**MOORE PUBLIC SCHOOLS -
WESTMOORE HIGH SCHOOL
ENTRY UPGRADES**

ADDENDUM NO. 1

May 20, 2026

Project Information

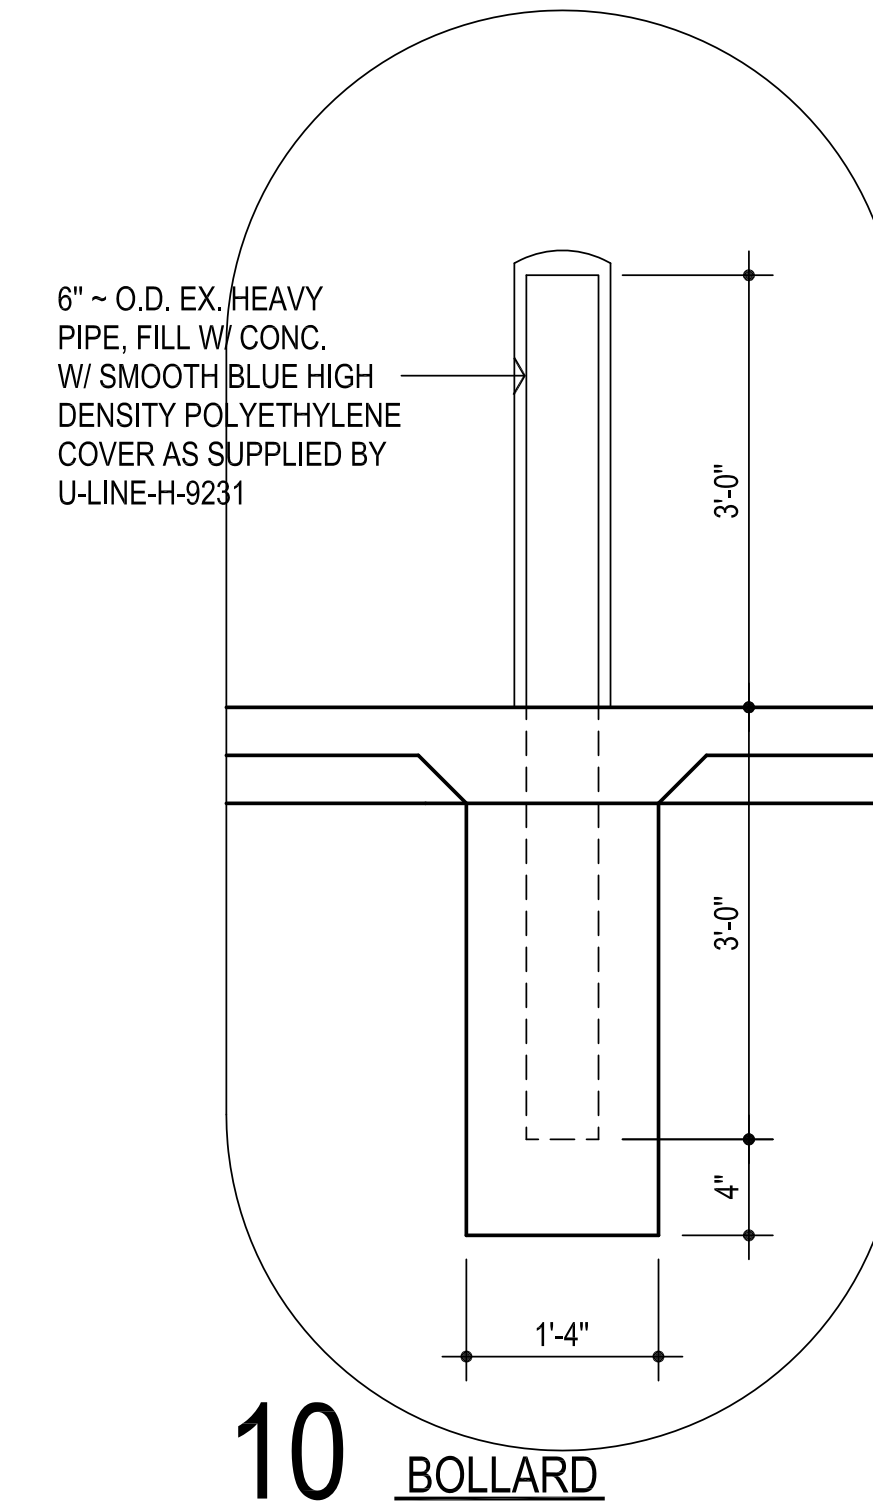
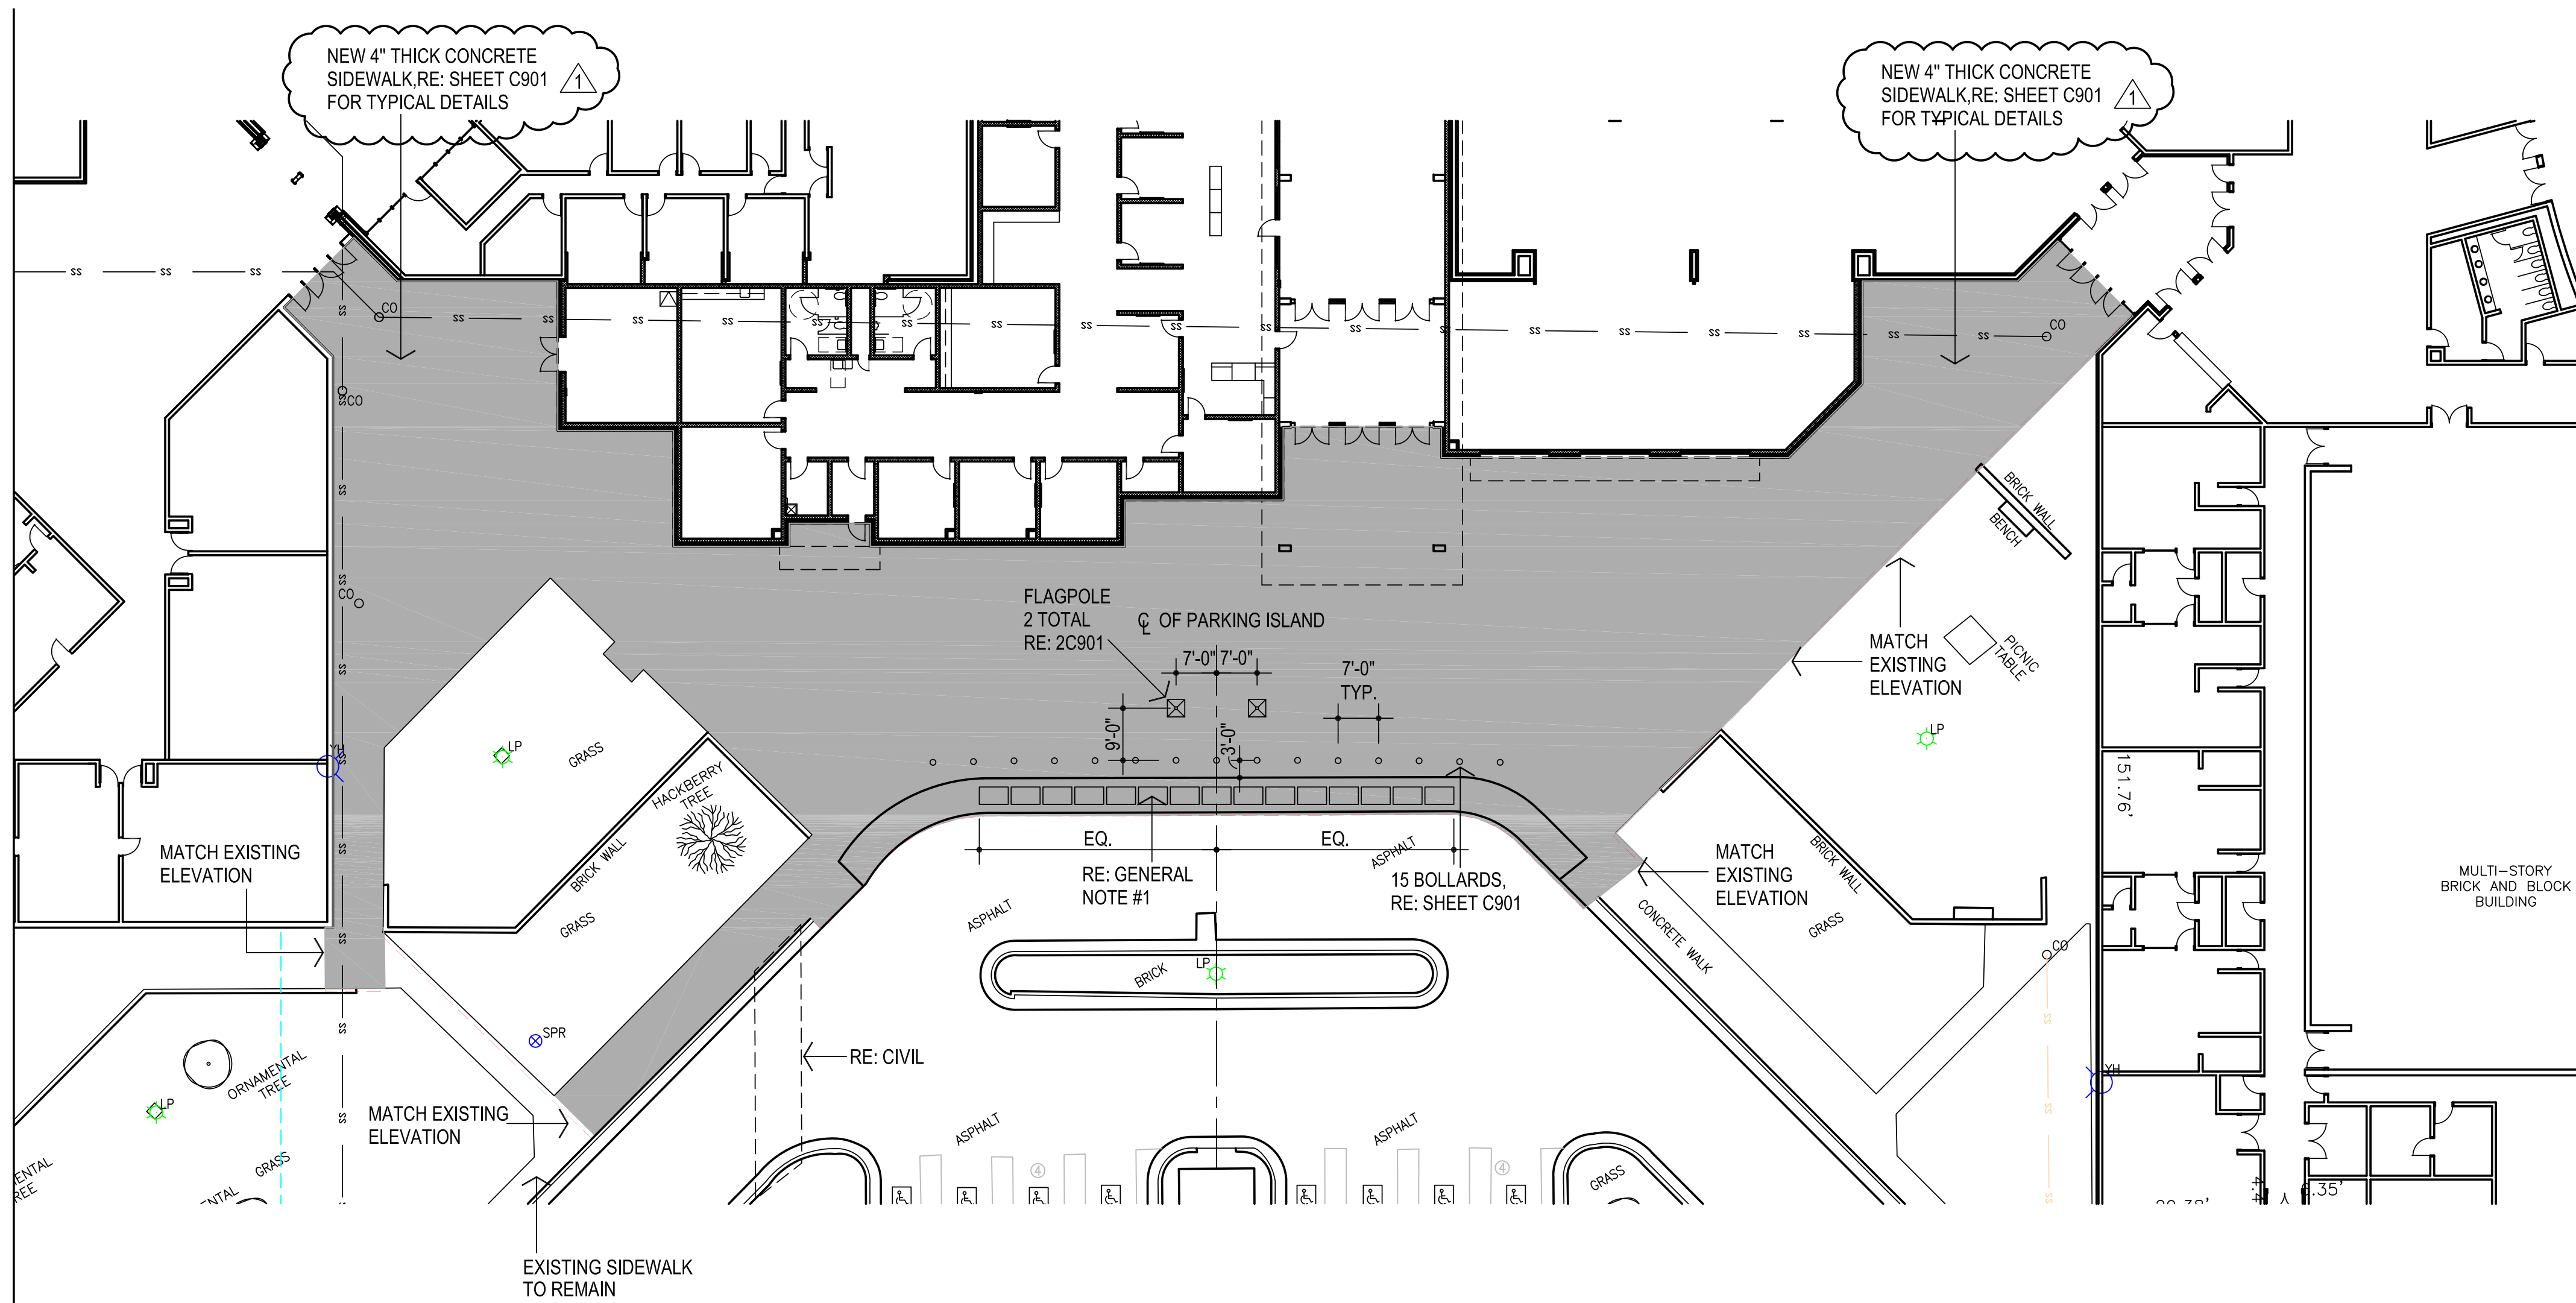
3. Sheet A601, Detail 2, Color Schedule – Item 5: omit reference to stair stairs and handrails (not applicable). Added “cast iron downspouts”. Refer to attachment.

4. Sheet A601, Detail 2, Color Schedule – Items 14 & 15 Ceramic Tile: revised tile colors. Refer to attachment.
5. Sheet A601, Detail 2, Color Schedule – Item 18 Solid Surfacing: revised solid surface countertop color as noted. Refer to attachment.

6. Sheet A601, Detail 2, Color Schedule – Item 29 Prefinished Metal Canopy: prefinished metal flashing, etc. relative to the metal canopies that is not provided by canopy supplier/manufacturer shall match the canopy color – Regal Red.

7. Sheet A601, Detail 2, Color Schedule – Item 32 Prefinished Metal Soffits: prefinished metal soffits and composite wall panel colors are to be Kynar 500 Black in lieu of Berridge color as noted. Refer to attachment.

8. Sheet A601, Detail 2, Color Schedule – Item 33 Prefinished Coping and Miscellaneous Flashing: noted color required. Refer to attachment.

1 SIDEWALK / PAVING SITE PLAN
1" = 20'-0"

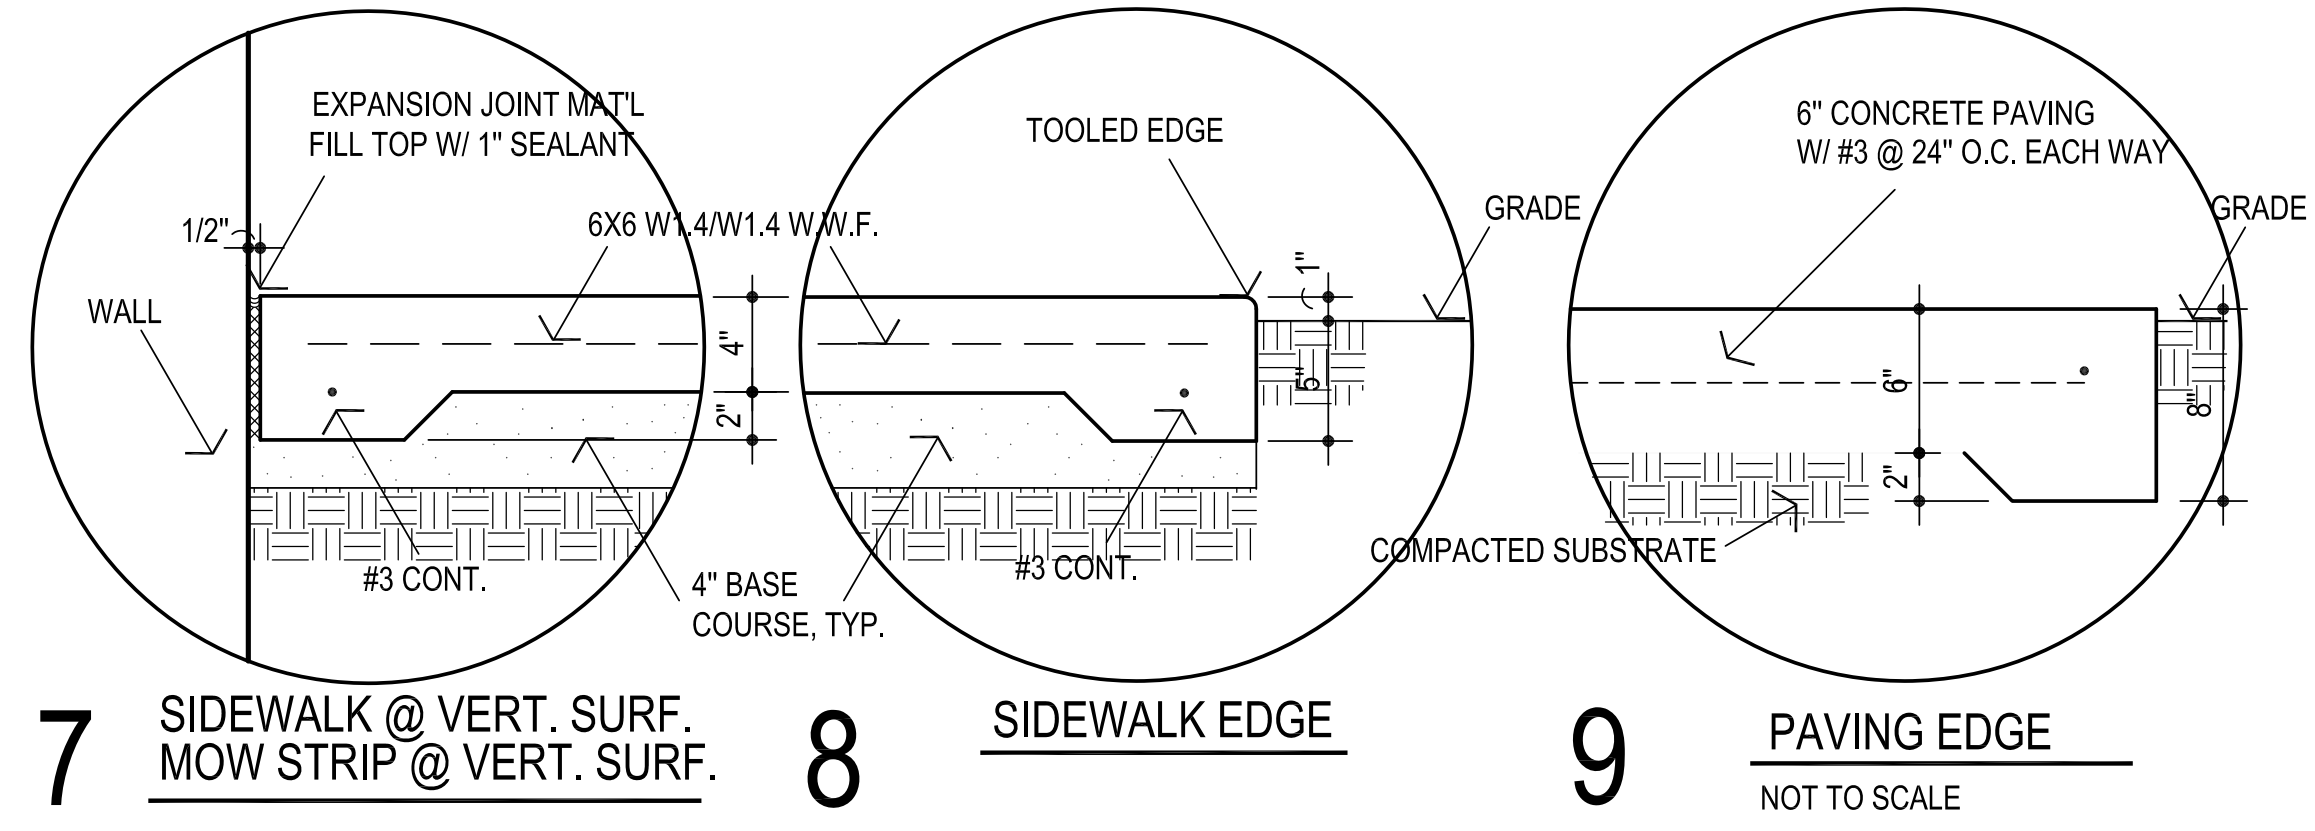
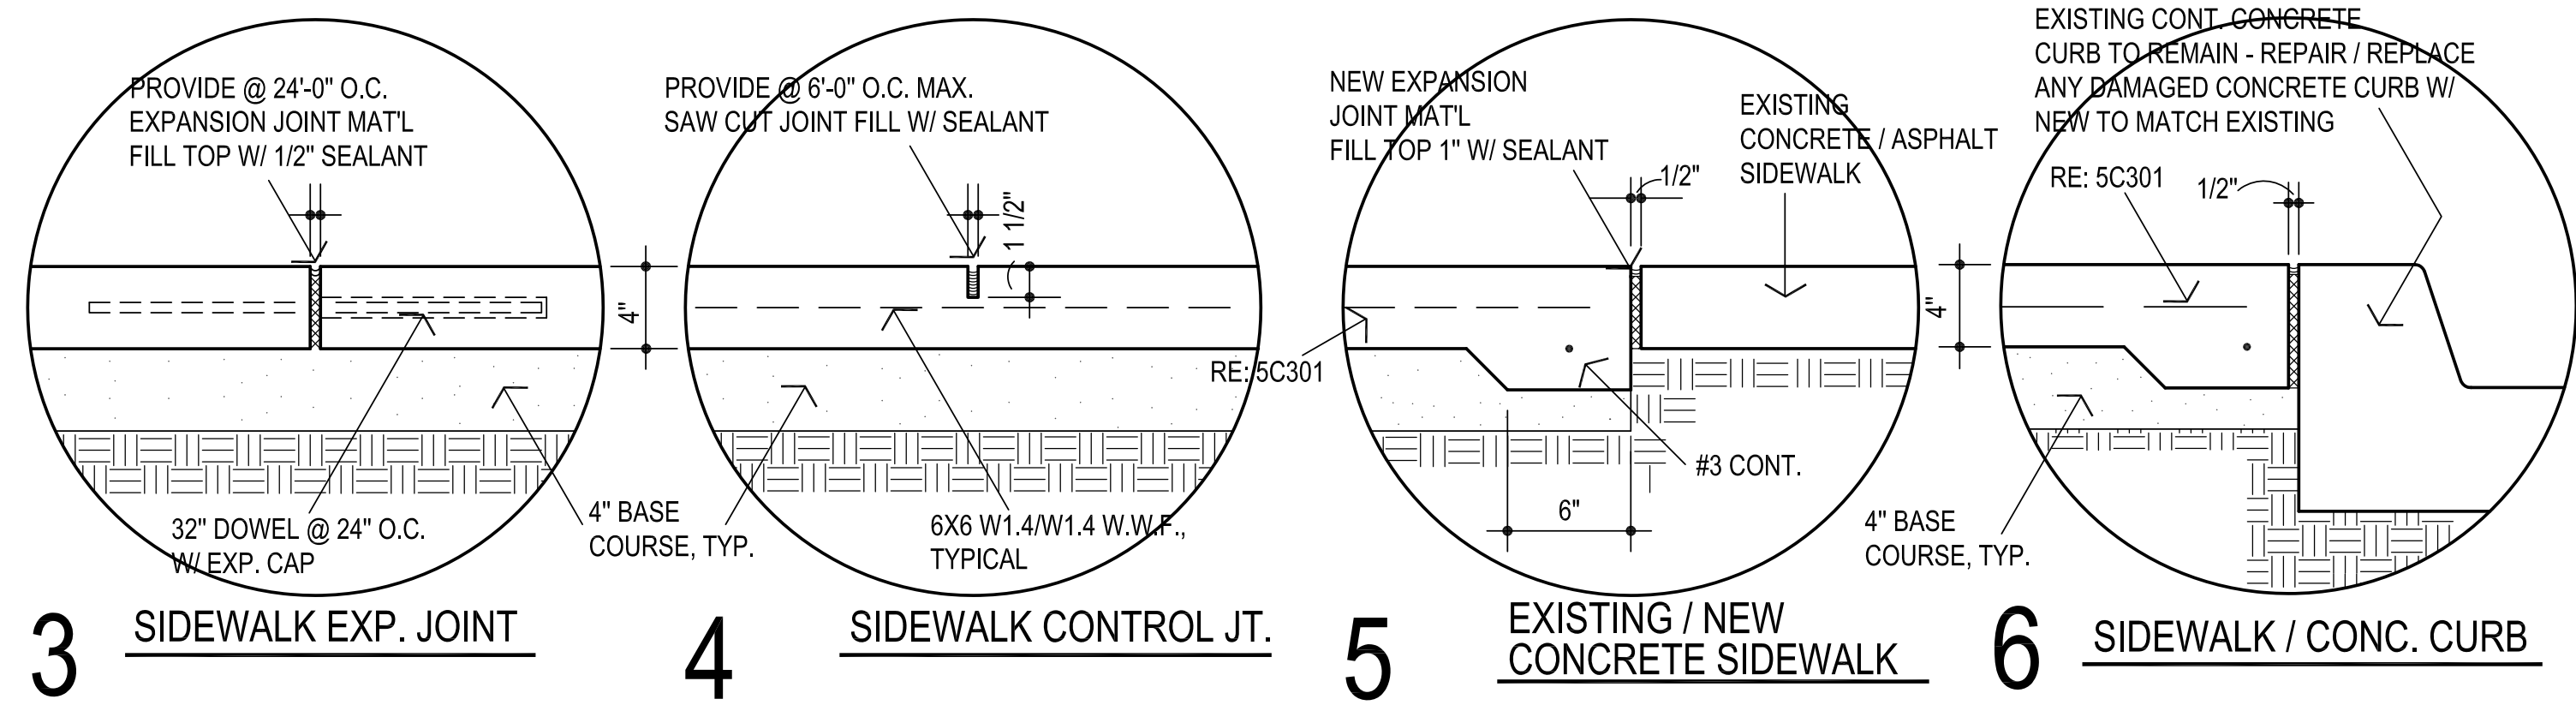
1. Sheet C901, Sidewalk / Paving Site Plan: revise sidewalk references as noted. Refer to attachment.
